After VLCW06

Dear MDI panel (from H.Yamamoto, 26 July 2006);

I would like to comment on the BDS change control (CC);

Preliminary Conclusion

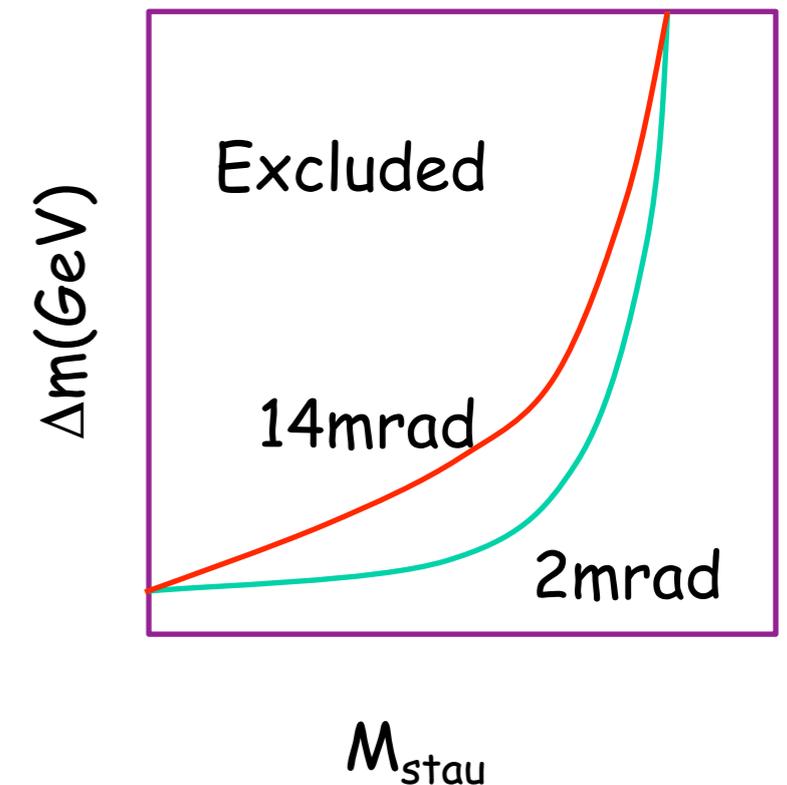
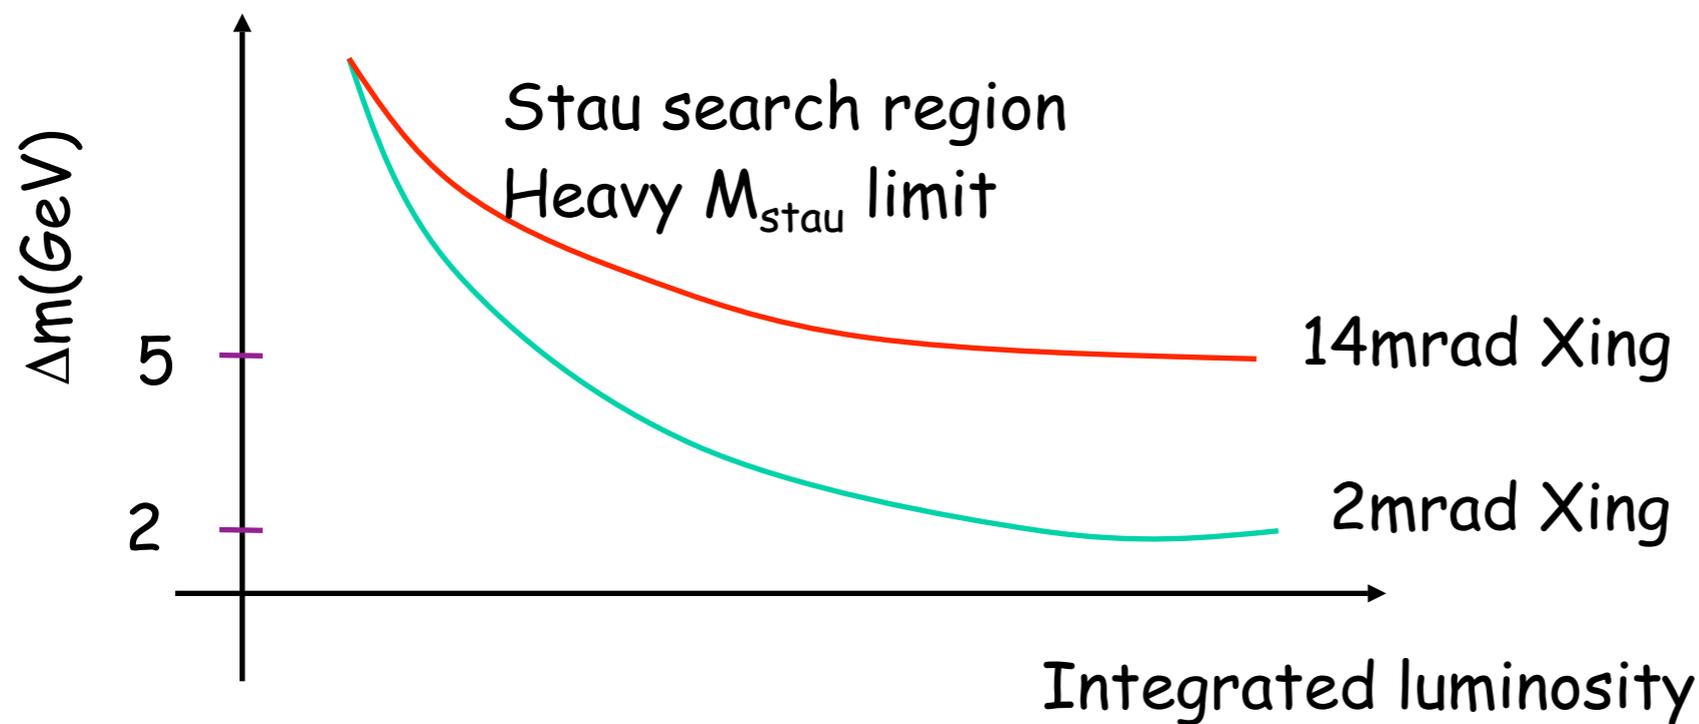
- Preliminary conclusion by a wild guess from a low stat. data
 - ◆ For $P_t > 5\text{GeV}$, Loss of efficiency of about 50% by putting cut on azimuthal angle.
 - ◆ The region below 5 GeV : will be hard to remove two-photon $e\bar{e}\tau\tau$ events
